P-16257
26946

JINDAL SYMBOL OF QUALITY AN ISO 9002 COMPANY	*JINDAL ALUMINIUM LTD.* *BANGALORE-560073 (INDIA)*		NAME	DATE
		DRAWN	*J.P.KAUSHIK*	24-10-2016
		CHECKED		
		APPROVED	B.NATARAJ	26-10-2016
1. ALL DIMENSIONS ARE IN mm. 2. ROUND OFF ALL SHARP CORNERS WITH 0.40 mm. 3. TOLERANCES WILL BE AS PER BS:EN-755-9, UNLESS OTHERWISE SPECIFIED		SCALE		2:1
		AREA mm^2		135.341
		PERIMETER mm.		261.614
PARTY'S NAME	KBE INTERNATIONAL SAL, LEBANON MIDDLE EAST	WEIGHT kg/m		0.365
		DRAWING No.		SECTION No.
PARTY'S DRAWING No.	AS PER AutoCAD DRAWING-1464	P-16257		–
ALLOY & TEMPER	6063 T6	26946		26946(ISSUE-2)
DESCRIPTION	AIR GRILL SECTION

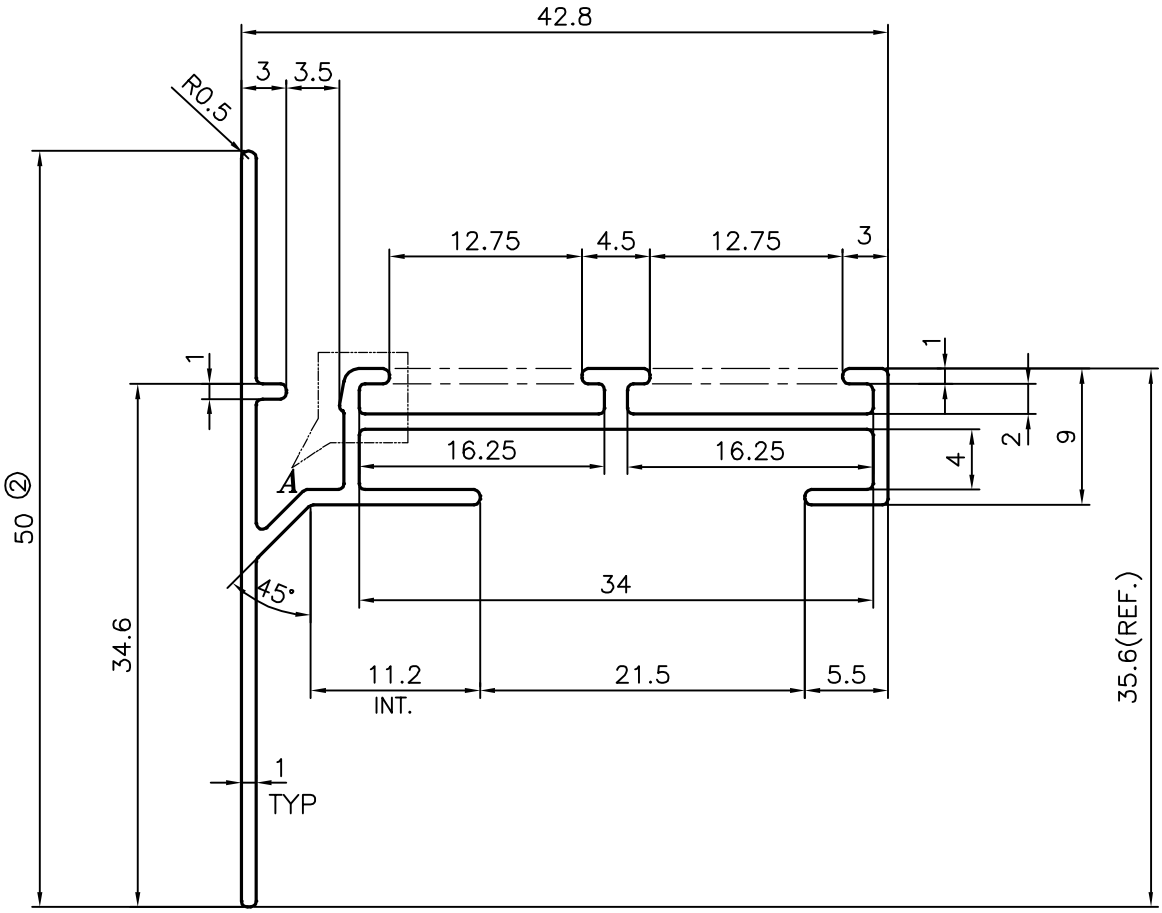
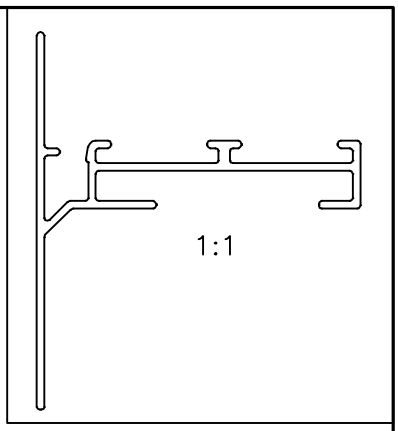
ISSUE-2

DIMENSIONS CHANGED FROM 48 TO 50 mm

WEIGHT ALSO CHANGED FROM 0.360 kg/m TO 0.365 kg/m
